Service Bulletin

3/27/2018

X, Y and X2 Drives

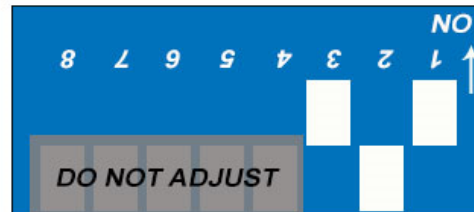
This bulletin pertains to machines with model number KL-5056E stepper motor drives. It has come to our attention that some machine may have been shipped with the current setting on these drives set to the wrong position. Current is set by positioning the DIP switches on the drive.

To adjust the current setting on the drive, you will adjust switch 1, 2 and 3 to the diagrams below. Note that SeriesOne machines have 3 drives labeled X, Y and Z while XT machines have 4 drives labeled X, Y, Z and X2. Again, we are only adjusting switch positions 1,2 and 3. Switches 4 – 8 will be left alone. The drives are located in the upper left corner of the control box.

Shown upside down as installed in box
